PLANNING DEPARTMENT

Planning Commission Staff Report

Subject: Treasure
Project #: PL-08-00370
Author: Francisco Astorga, AICP, Senior Planner
Date: 08 March 2017
Type of Item: Administrative – Conditional Use Permit
 Introduction to CUP Criteria 4, 5, 6, 13, & 14

The following table, from Sheet P.16 Area, Unit Equivalent & Parking Calculations, below summarizes the applicant's proposed parking:

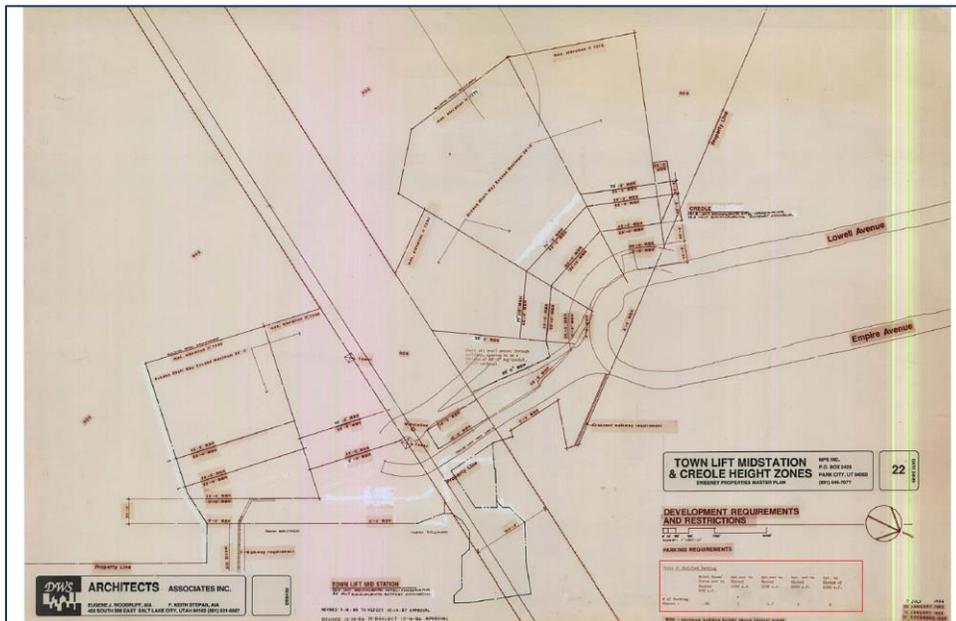
Staff has reviewed Sheet P.16 Area, Unit Equivalent & Parking Calculations and provides the following table to show the required number of parking spaces based on Table 2: Modified Parking:

The applicant applied Table 2: Modified Parking correctly based on their number of units as they indicated a total of 366 required parking spaces (applicant rounded down, while the LMC 50th Edition 15-3-6(C) indicates that it should be rounded up to the next whole number as the table does not indicate rounding).

The applicant then added 33 parking spaces to accommodate for the 6,669 square feet of employee housing proposed on-site. Because Table 2: Modified Parking did not provide an employee housing parking ratio, the applicant utilized the LMC 50th Edition (2004 LMC) § 15-3-6(A): Dormitory, residential parking ratio which is 1 parking space per 200 sf. floor area devoted to accommodations. Again, applicant rounded down instead of rounding up to the next whole number which is 34 employee parking spaces.

The applicant adds 25 parking spaces for allocated staff and service spaces at a rate of approximately 1 space per 12 units (according to the applicant). The proposed grand total is 424 parking spaces (366+33+25=424), as narrated above).

Exhibit B – Sheet V-7 Parking and Emergency Vehicular Access

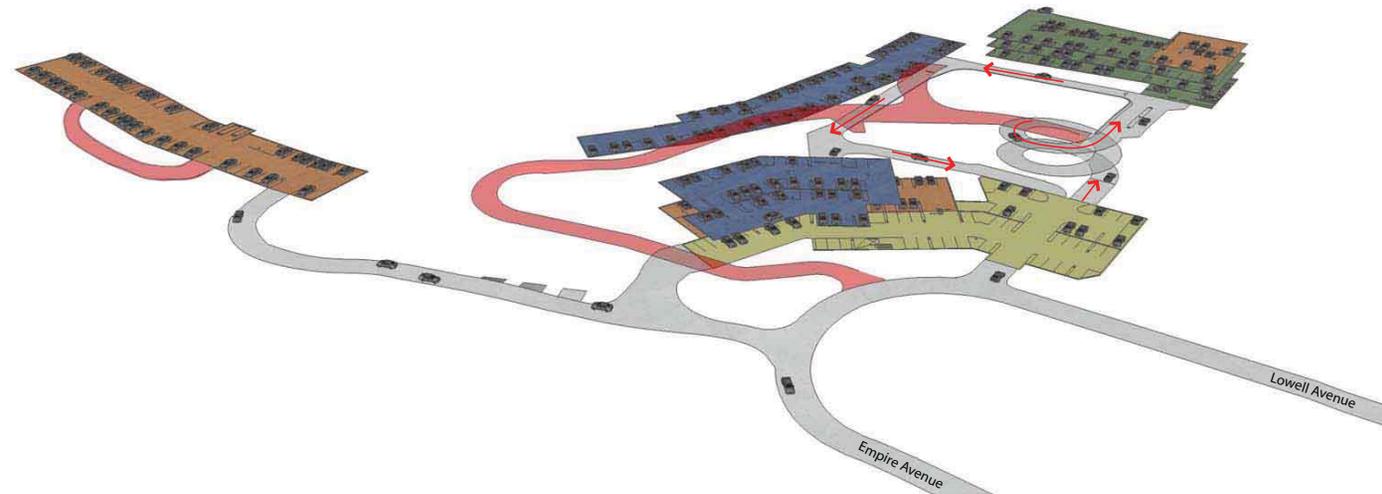
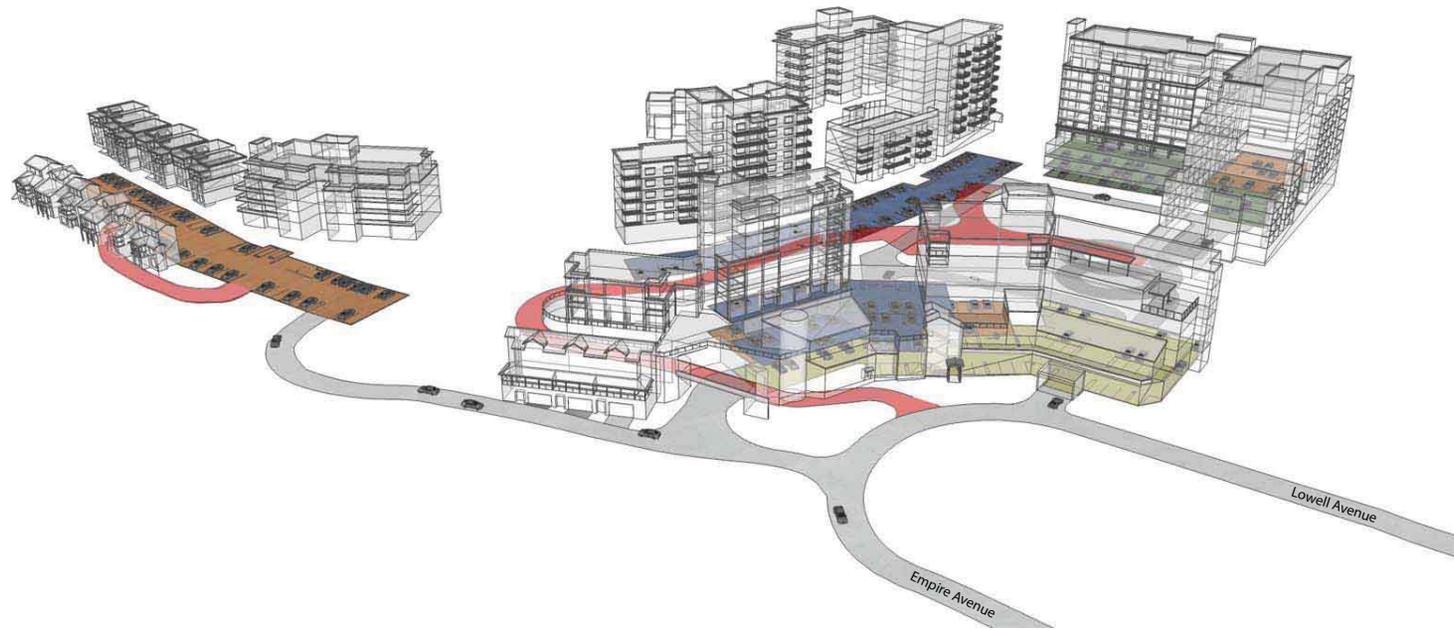
The set of plans updated in 2008 contain [Sheet V-7 Parking and Emergency Vehicular Access](#). Sheet V-7 indicates a total of 427 parking spaces being proposed and separates the parking spaces into four (4) areas: Hotel – 152 spaces, Club – 109 spaces, residential -110 spaces, and staff/visitor – 56 spaces. This sheet does not further clarify management or compliance with not drawing people from outside the development. Furthermore, this sheet assigns visitor parking. Staff would like to further understand how parking is to be managed.

Discussion Requested: Staff request to further understand how the applicant

plans on managing off-street (on-site) parking to assure compliance with Finding no. 4 and Development Parameter/Condition no. 3 in that all support commercial uses are oriented and provide convenient service to those residing within the project and not designed to serve off-site or attract customers from other areas. Does the Planning Commission agree with this statement?
